ADDENDUM NO. 2

PROJECT: **Alden Bridge Sports Park Phase 1**

FROM: Tyler Eaton, PE
Halff Associates, Inc.
14800 St. Mary's Lane, Suite 160
Houston, TX 77079

SHEET NUMBER:
C3.01

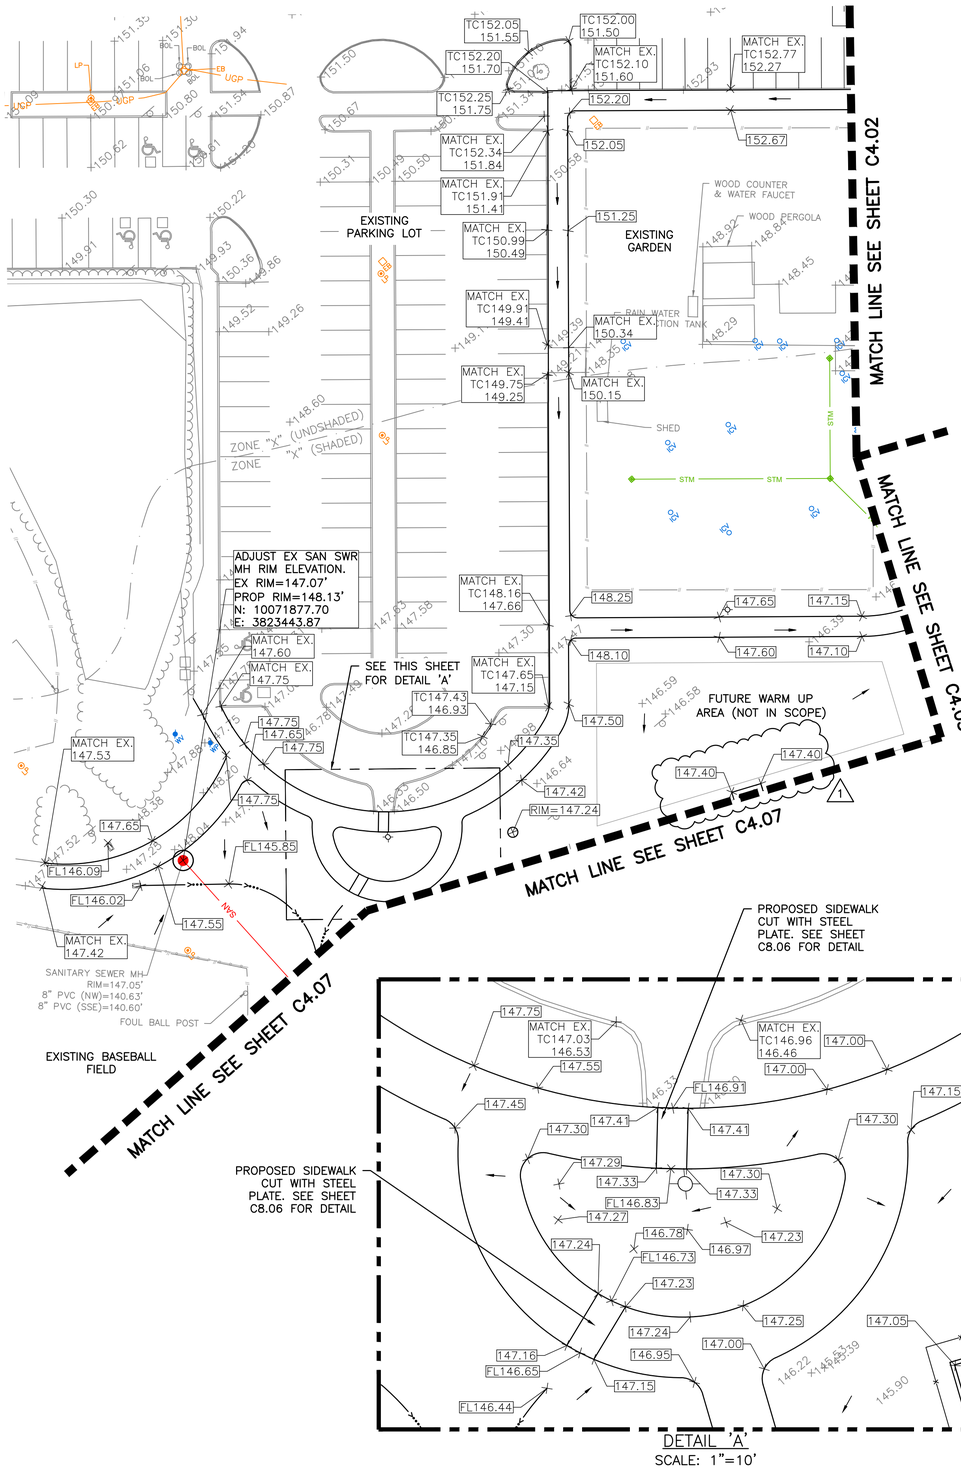
- Sheet G0.01 Index Sheet- L2.13 Flagpole Base Detail sheet added
- Sheet C3.01 Demolition Plan Detail- Keynote 22 description changed for new flagpole location

SHEET NUMBER:
C4.01

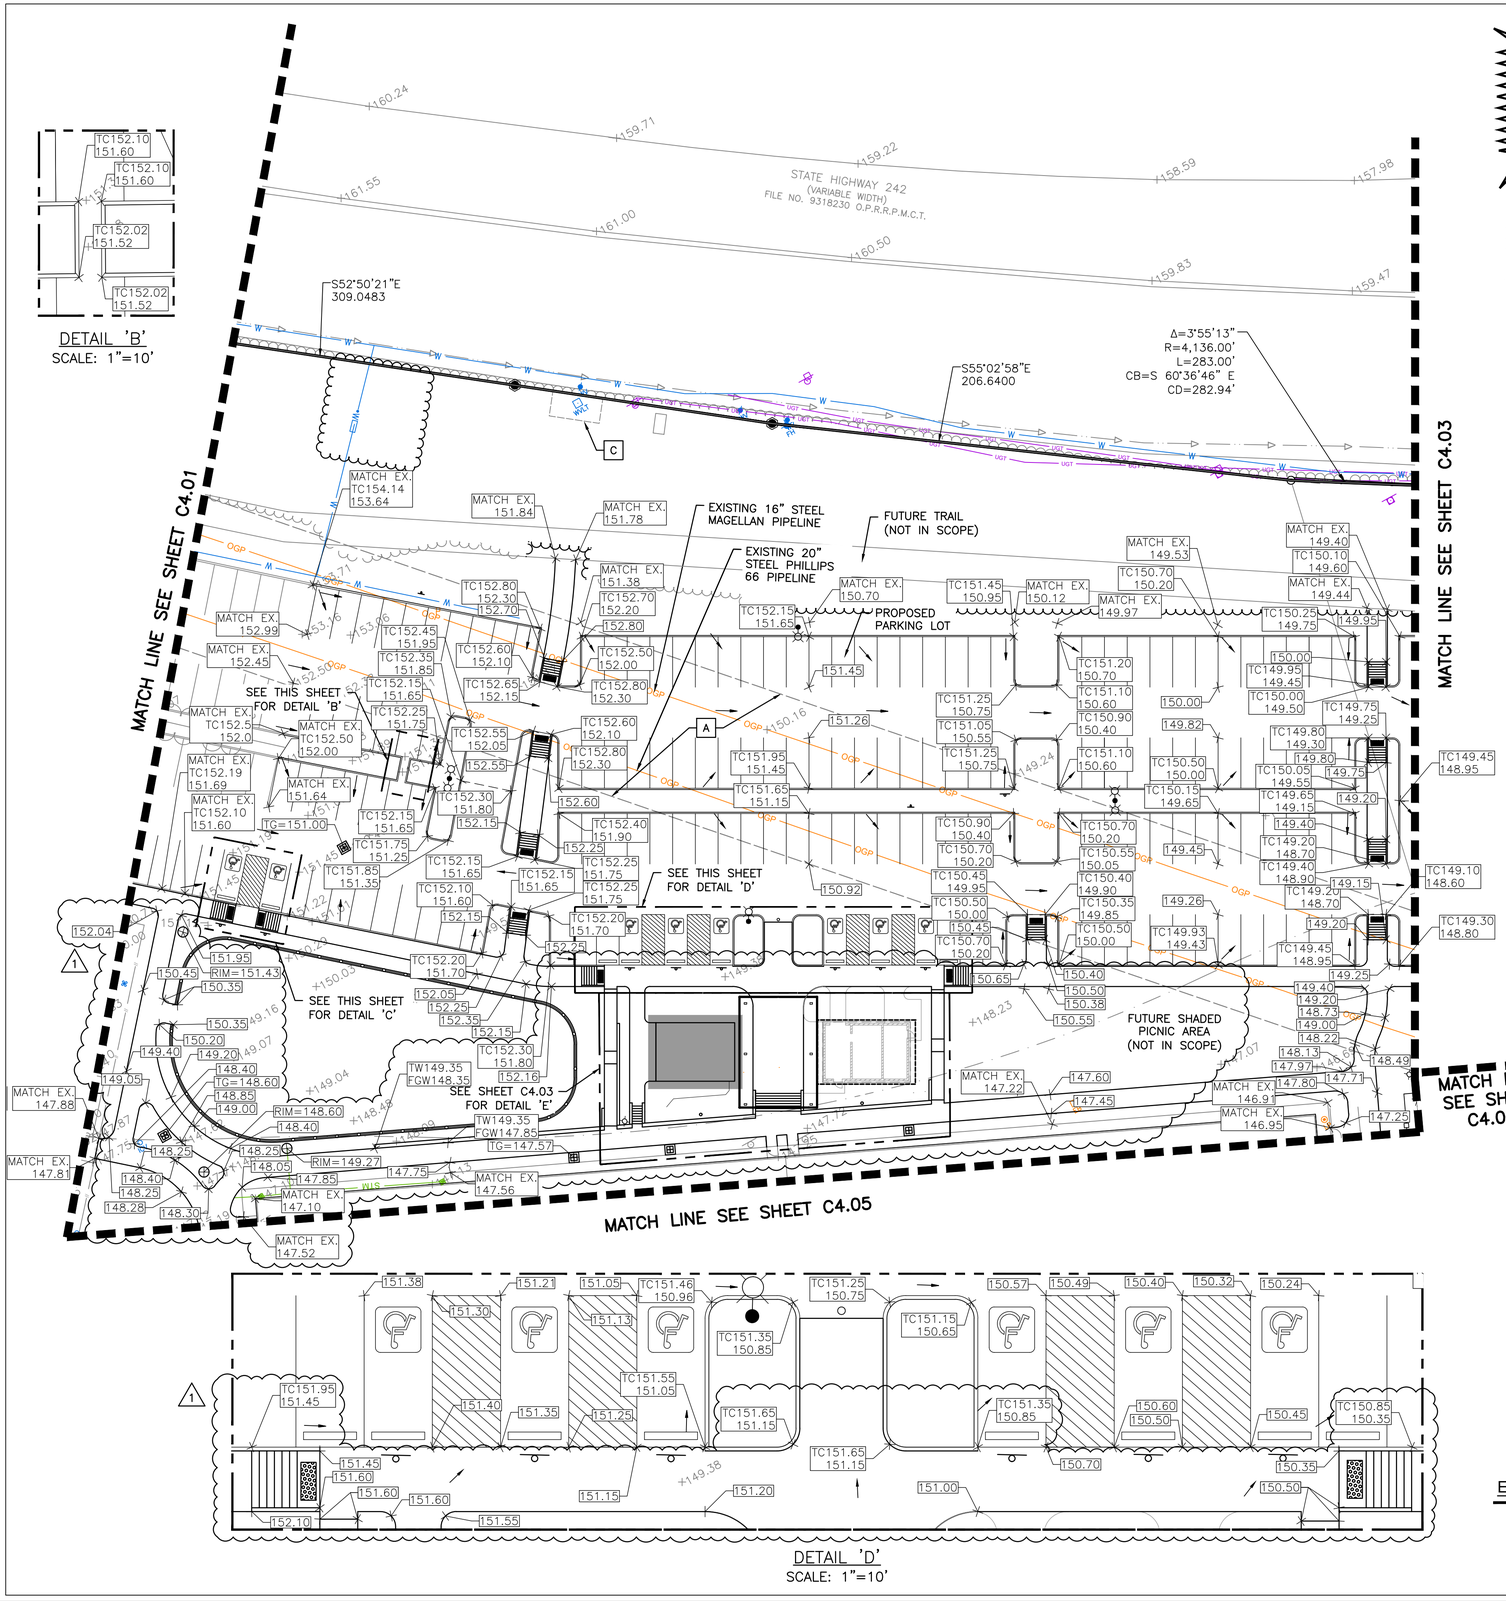
- Sheet C4.01 Grading Plan- Grades added for new flagpole pad
- Sheet C4.02 Grading Plan- Restroom and adjacent sidewalk building shifted west. ADA ramps and stairs added between parking lot and turf. Retaining walls and seat walls added. All affected grades have been updated. Playground limits decreased and entry point changed. West entry to the existing turf field. Detail 'C' callout added. ADA curb ramps in detail 'B' moved, detail 'B' expanded to capture ramps.

SHEET NUMBER:
C4.03

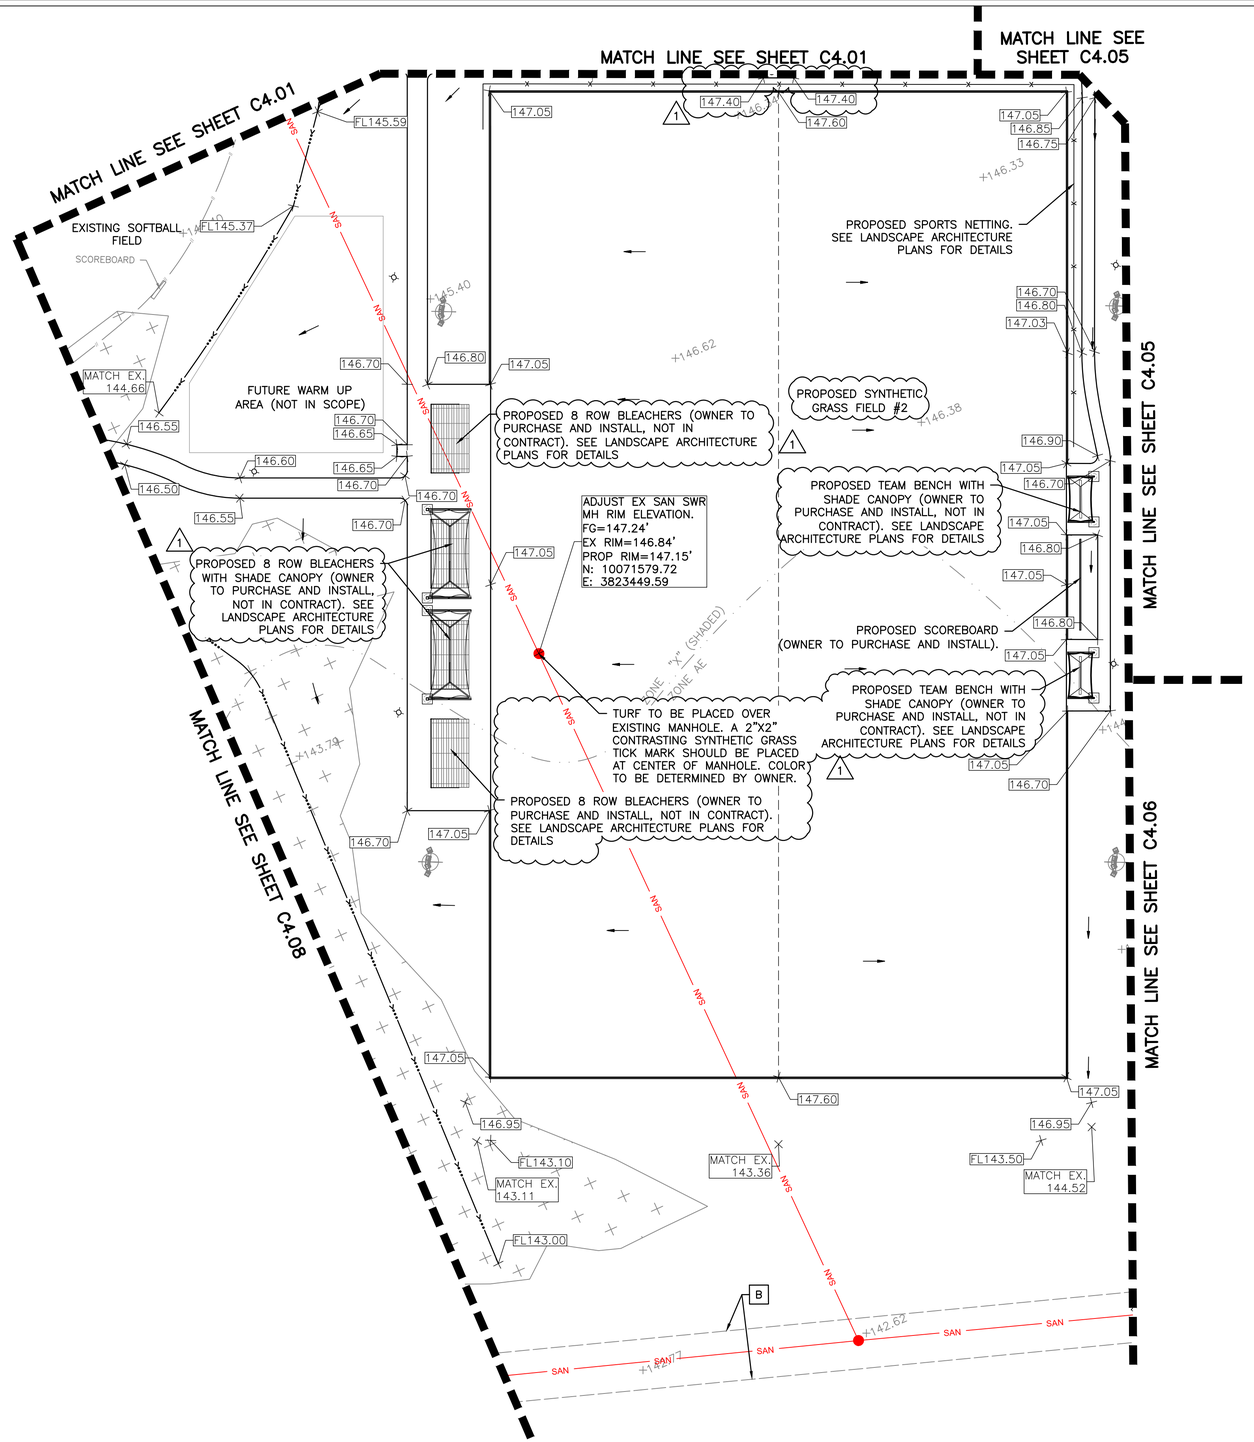
- Sheet 4.03: Detail 'C' has been added to this sheet showing seawalls, retaining walls, ADA ramps and stairs that have been added to make the grades work. All grades in this area have been updated. TW, FGW and TS grades added to legend for Top wall, Finished grade wall and top of step.

SHEET NUMBER:
C4.07

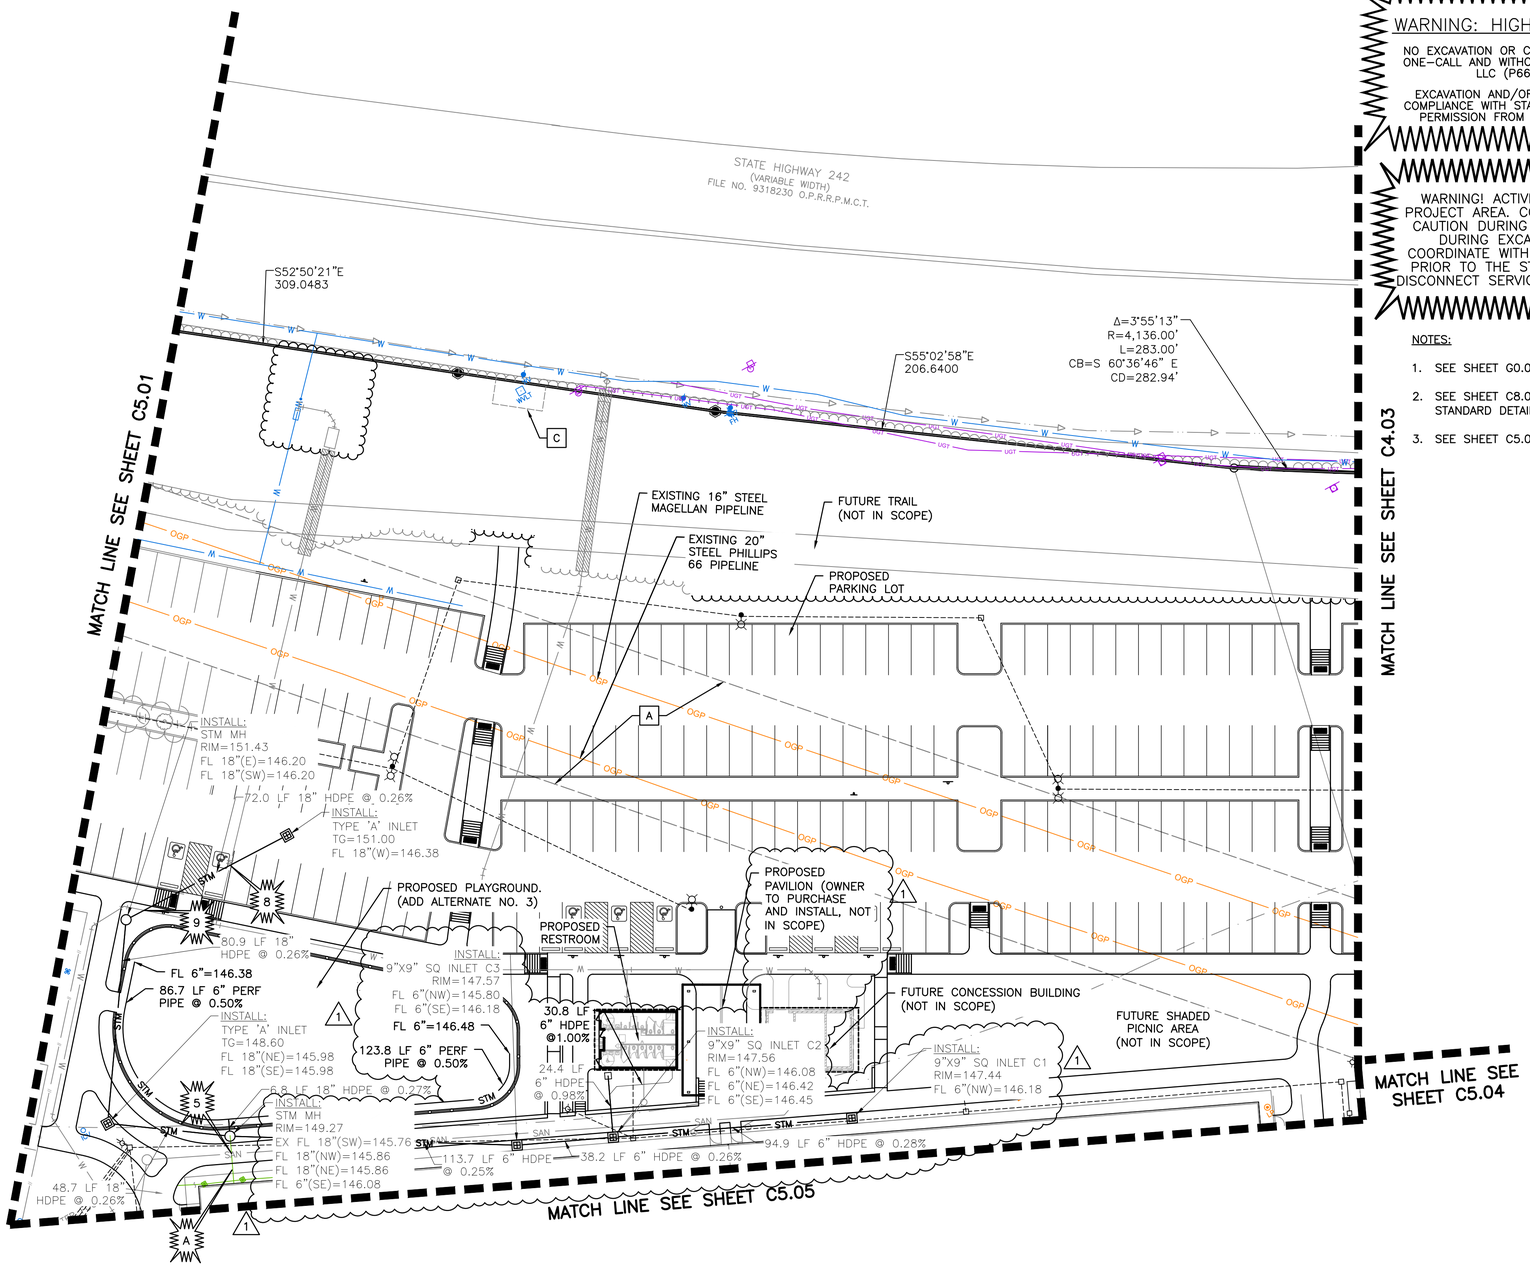
- Sheet C4.07 Grading Plan-Grades added for new flagpole pad
- Sheet C5.02 Storm and Drainage Plan – Added 9"x9" square inlet and 6" HDPE pipe and updated top of grate and rim elevations for Type 'A' Inlet and Storm Manholes

SHEET NUMBER:
C6.00

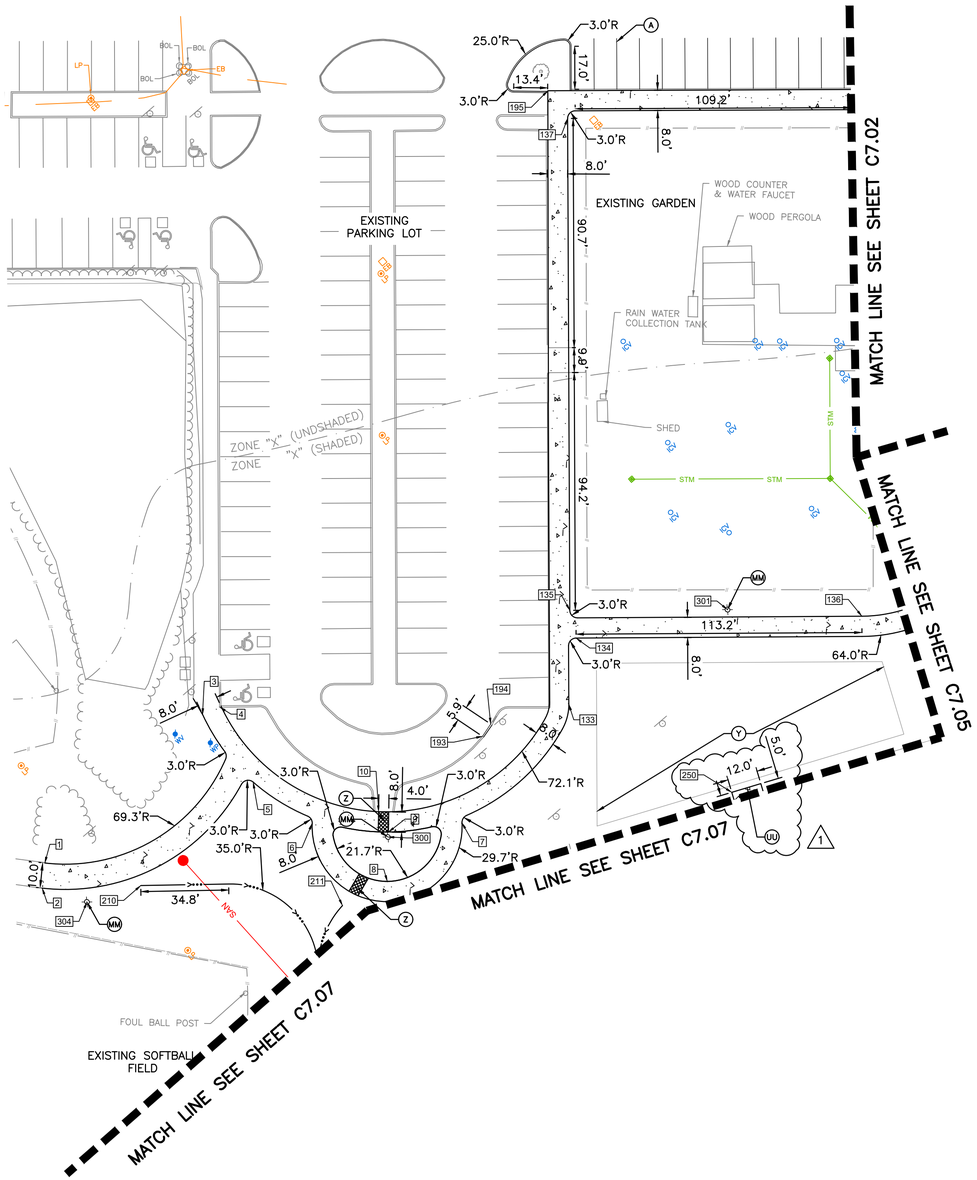
- Sheet C6.00 Water and Wastewater Plan-Added Crossing 'A' for conduit connecting to flagpole uplight.
- C7.01 Paving and Dimensional Plan- Dimensions, Northing Eastings and Keynote "UU" has been added for the new flagpole pad.

SHEET NUMBER:
C7.02

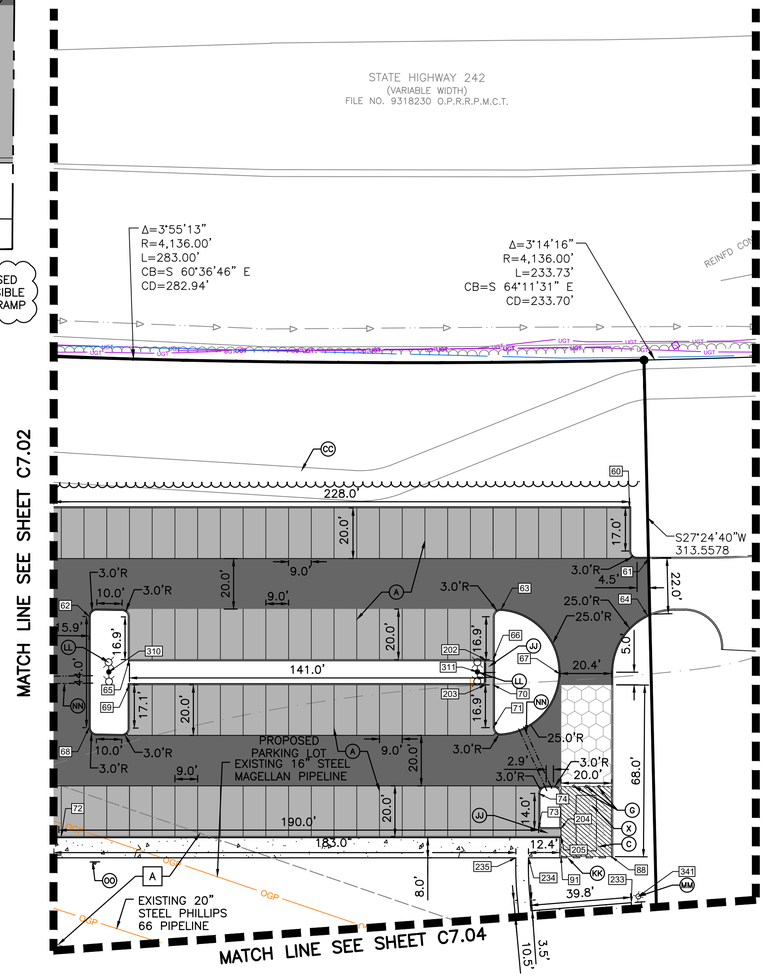
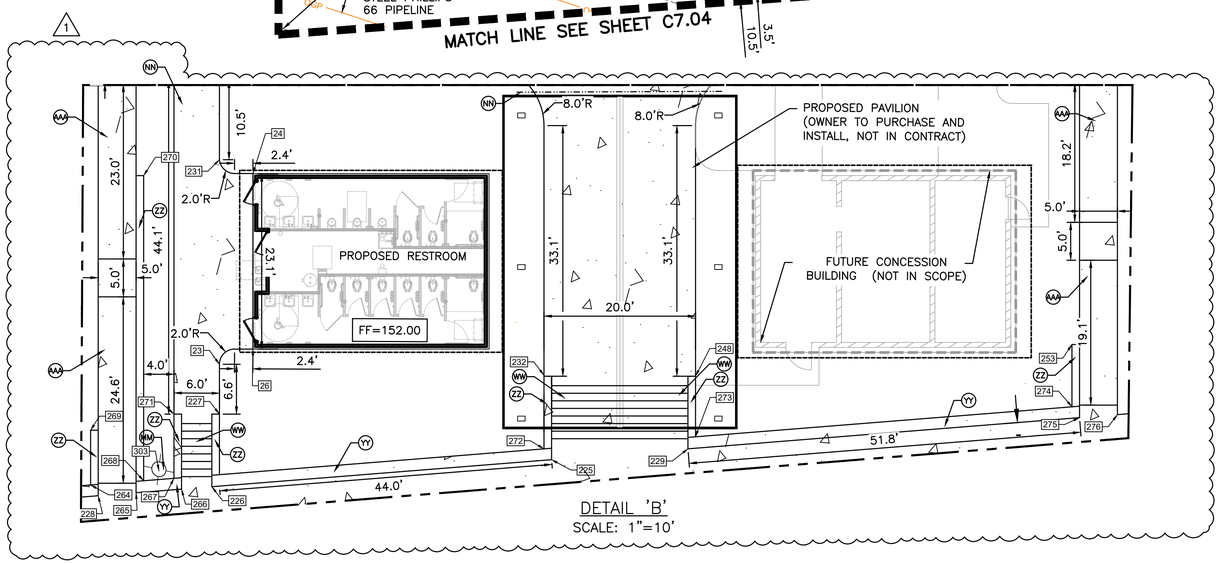
- C7.02 Paving and Dimensional Plan- Sidewalk west of restroom shifted west to avoid pavilion foundation and sidewalk conflict. ADA ramps and stairs were added between parking lot and turf fields to help with grade transitions. Retaining walls and seat walls added. All affected dimensions, northing and eastings and sidewalk have been updated. Playground limits decreased and entry point changed. West entry to the existing turf field changed to align with existing gate. Detail 'C' callout added. ADA signs shifted to be closer to parking stalls. ADA curb ramps in detail 'B' moved, detail 'B' expanded to capture ramps.
